**Bid Addendum One**

Project: **Tullip New Utilities Building**  
Project No. Tulalip Tribes Project No. 2021-003

Date of Issuance: April 16, 2024

Issued By:  
Freiheit Architecture

**12** EAST ELEVATION - EXTERIOR STAIR

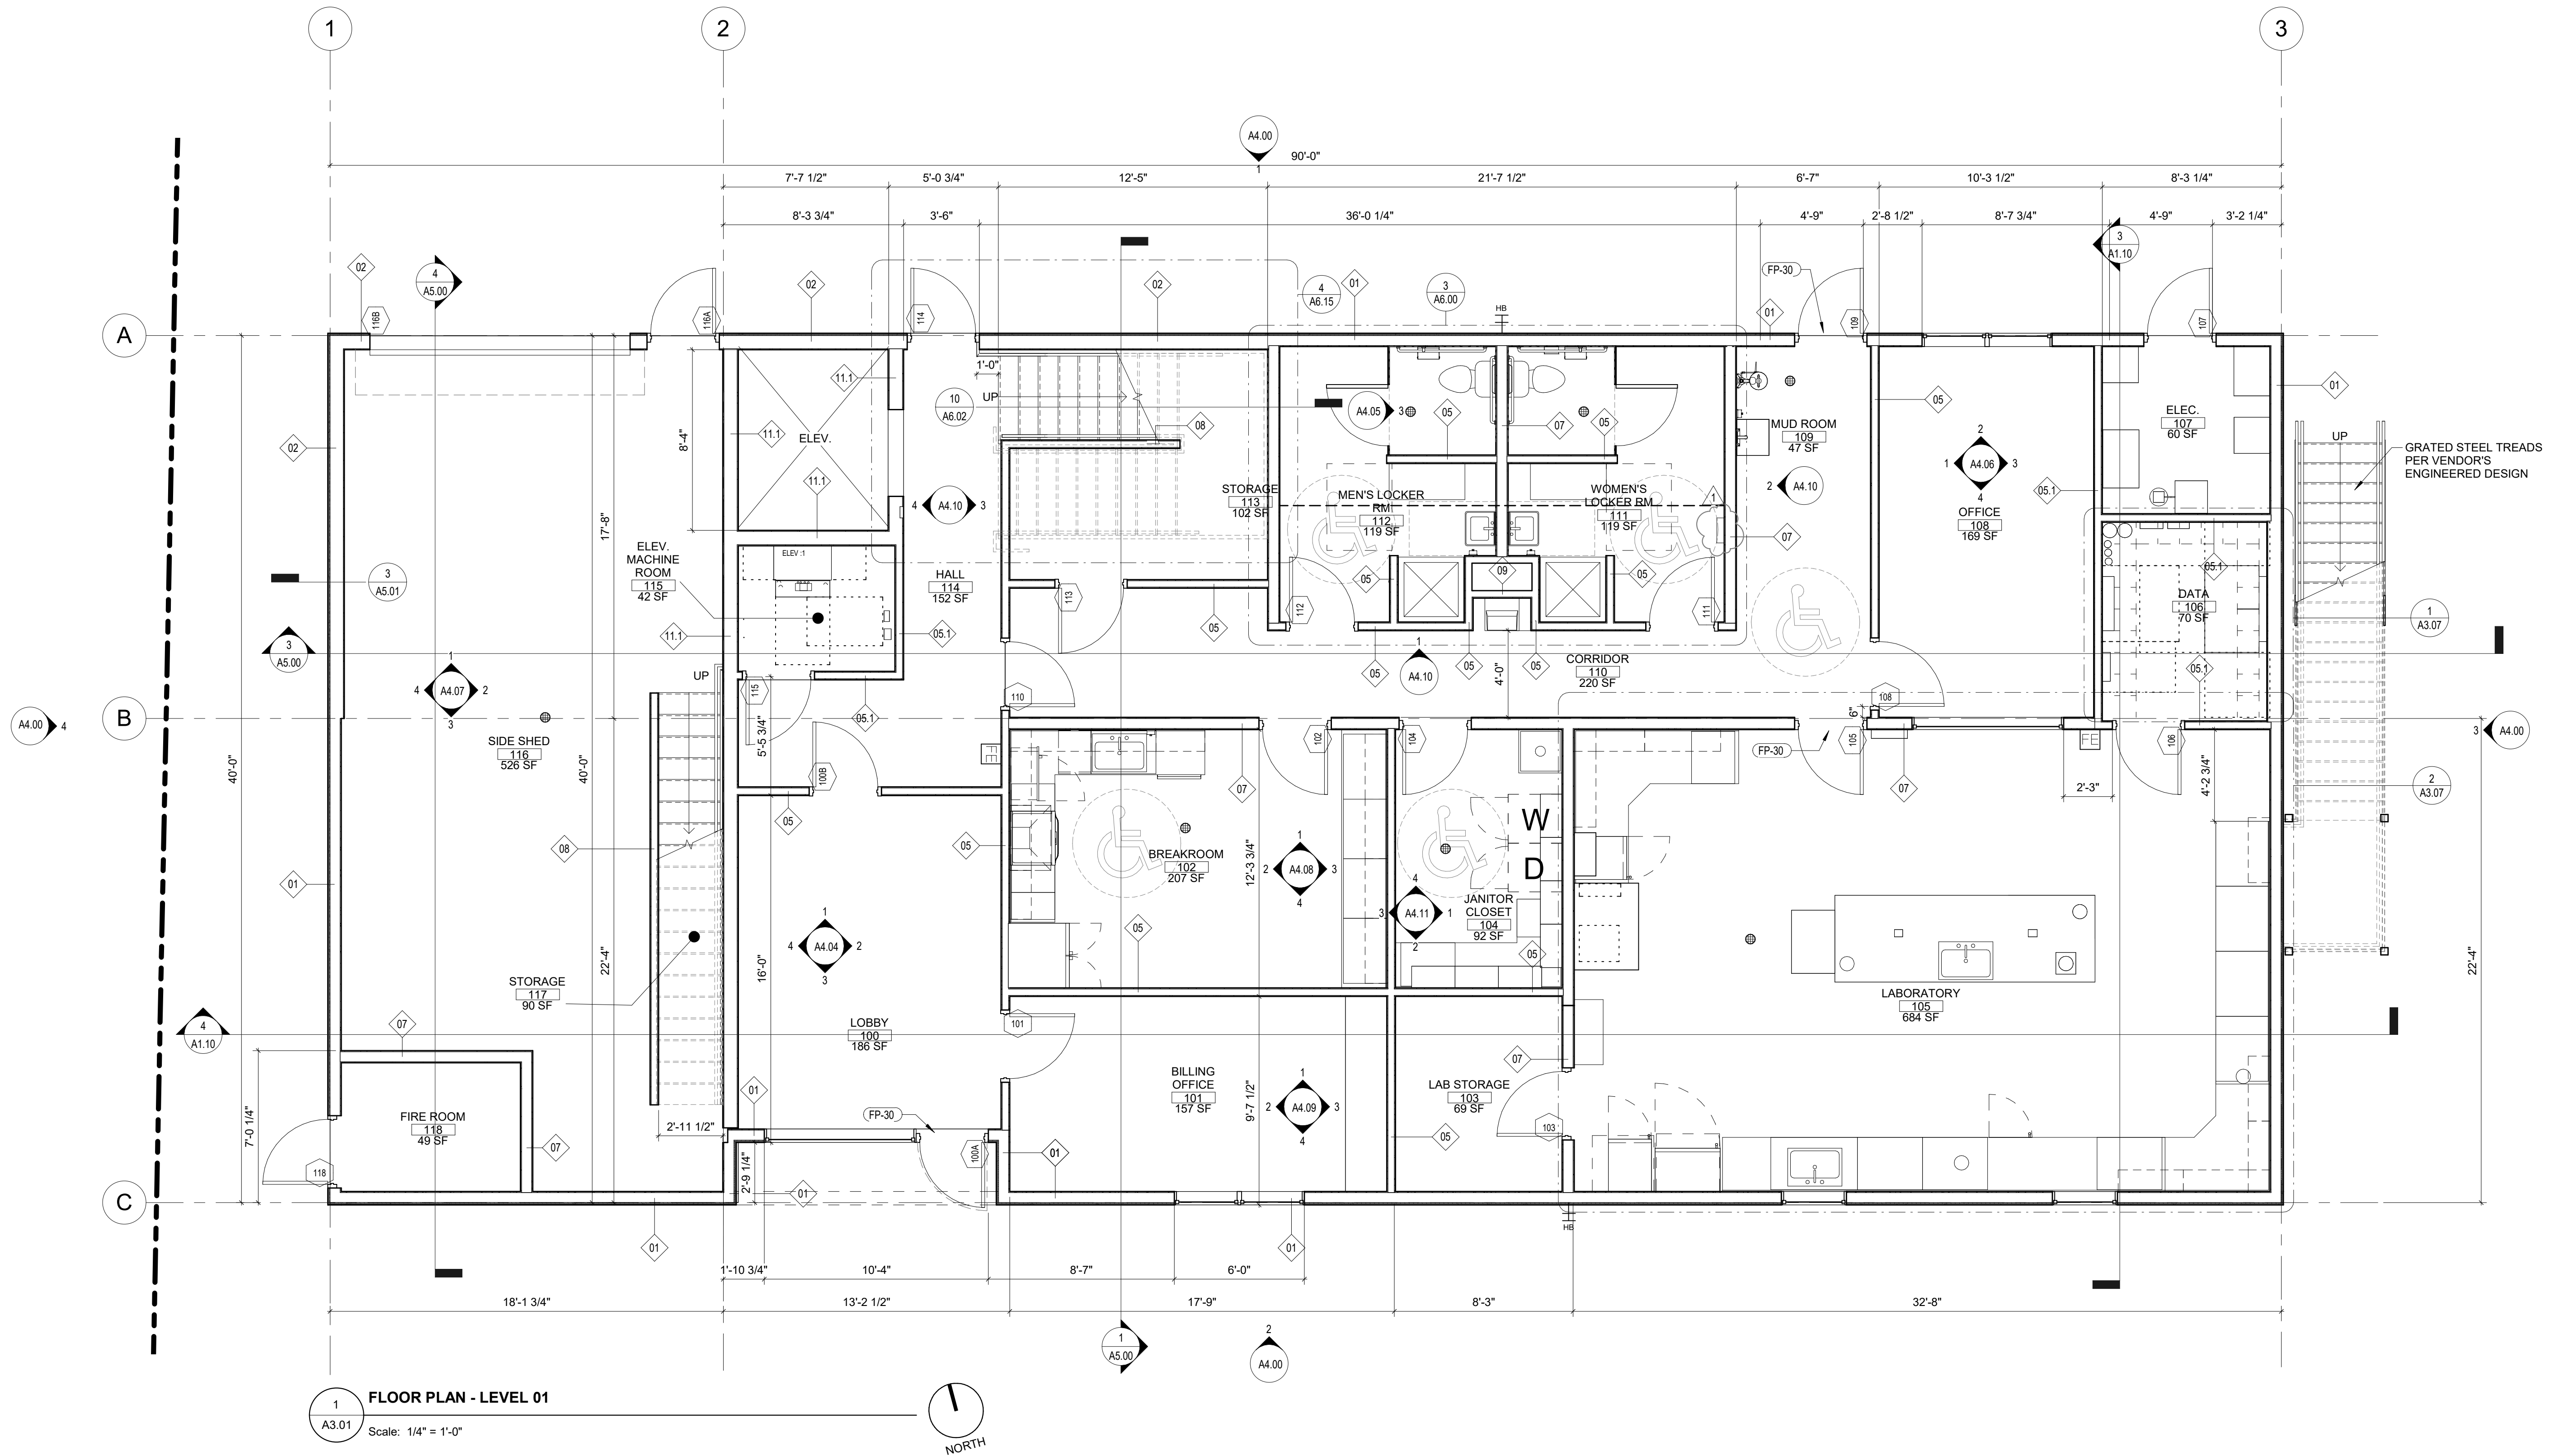
1. S3.02 elevation 12 – East Elevation – Exterior Stair – This Elevation is not given on Architectural or Civil Sheets. Please Advise. (see attached)
2. Detail 6, 7, & 12 on S4.11 Refer to top of Stem wall or Retaining wall 'as per Arch' – This Elevation is not given on Architectural or Civil Sheets. Please Advise. (see attached)

4. Architectural Set Sheet A4.00 Detail 3 Shows Steel stairs with metal picket handrail. Structural sheet S3.02 Detail 12 shows the exterior wall with Framed exterior wall with 4x6 post. Please Advise If wood framed wall is needed.

Architectural Set Sheet A4.00 Detail 3 Shows Steel stairs with metal picket handrail. Structural sheet S3.02 Detail 12 shows the exterior wall with Framed exterior wall with 4x6 post. Please Advise If wood framed wall is needed.

- 4. ***East Stairway is changed to vendor design metal fabricated stair with canopy at top landing. Structural Drawings are revised to match Architectural with Bid Addendum 1 issue.***

**1 FLOOR PLAN - LEVEL 01**  
A3.01 Scale: 1/4" = 1'-0"

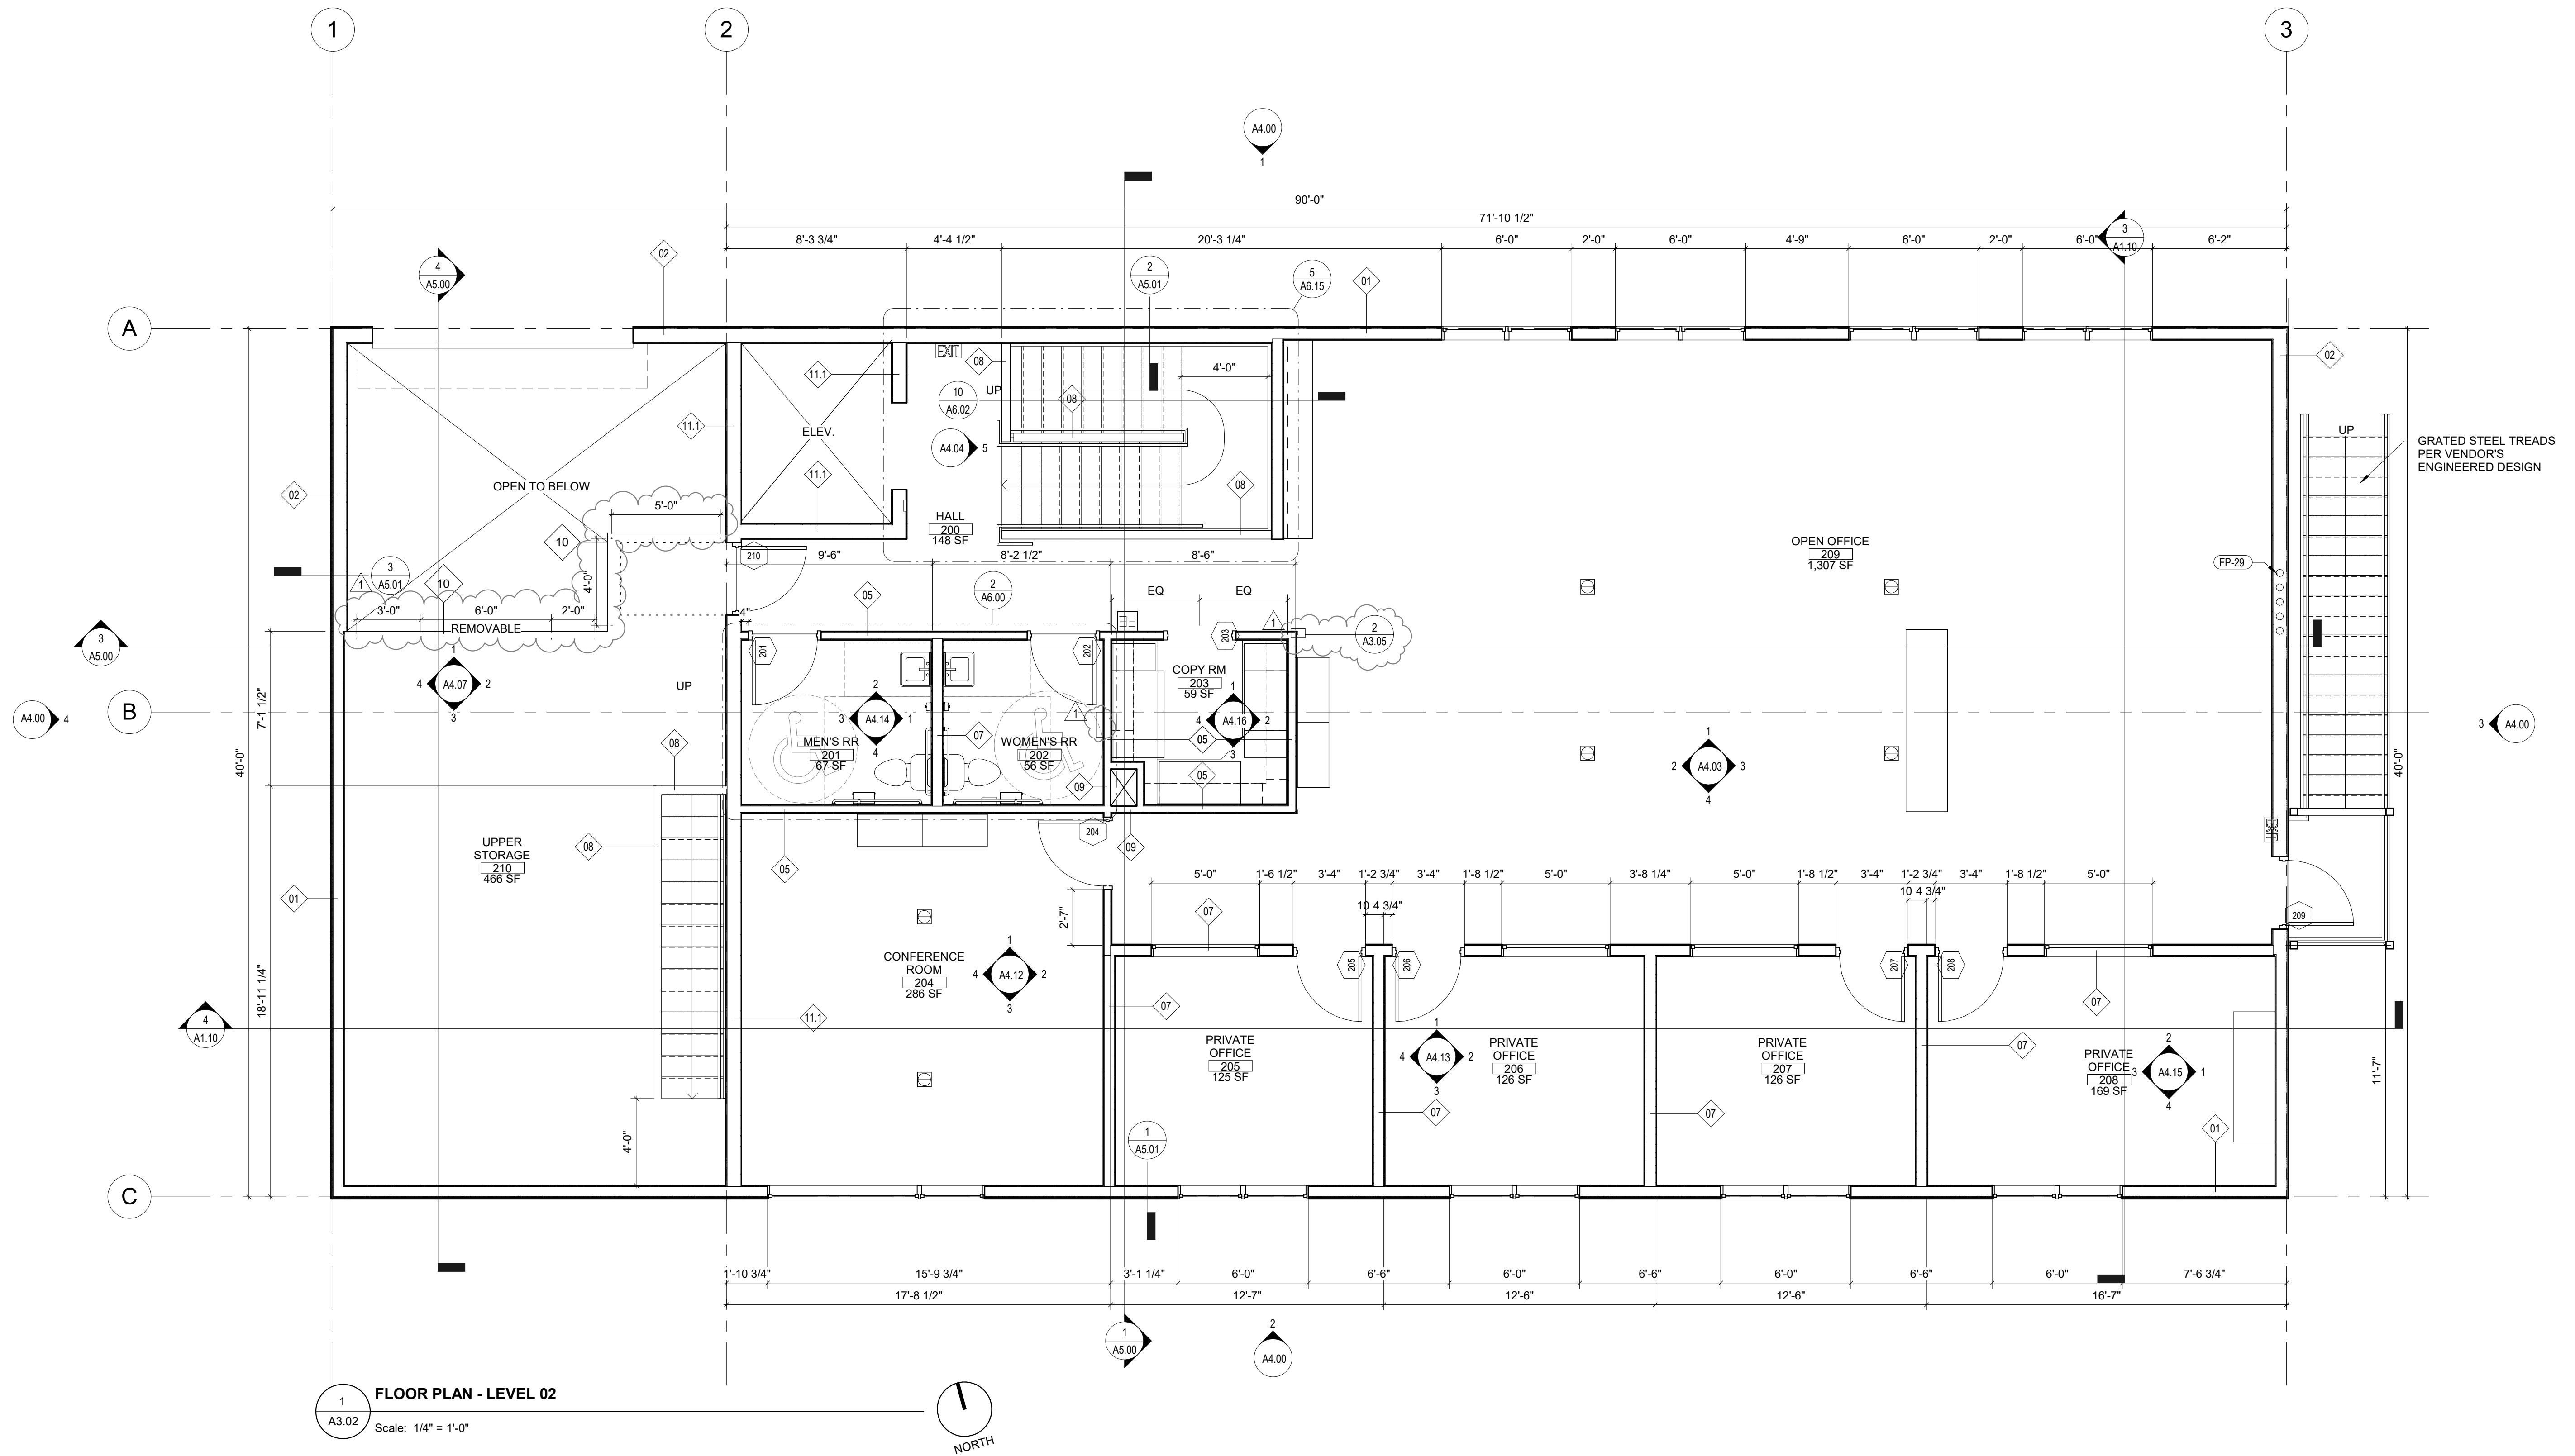
5. 1 on A3.01 Floor Plan – Level 01 calls out Grated Steel Treads per vendor's engineered Design. Section 055100 – Design-Build Steel Stairs Part 1, 1.1, B indicates Concrete fill for Metal Pan treads. Please advice.

1 on A3.01 Floor Plan – Level 01 calls out Grated Steel Treads per vendor’s engineered Design. Section 055100 – Design-Build Steel Stairs Part 1, 1.1, B indicates Concrete fill for Metal Pan treads. Please advice.

- 5. ***Spec Section 055100 is revised to indicate Steel Grate Treads with Bid Addendum 1.***
- 6. ***Answer Pending***
- 7. ***Answer Pending***
- 8. ***Section 123200 to be revised for Bid Addendum 1. Finishes as follows:***
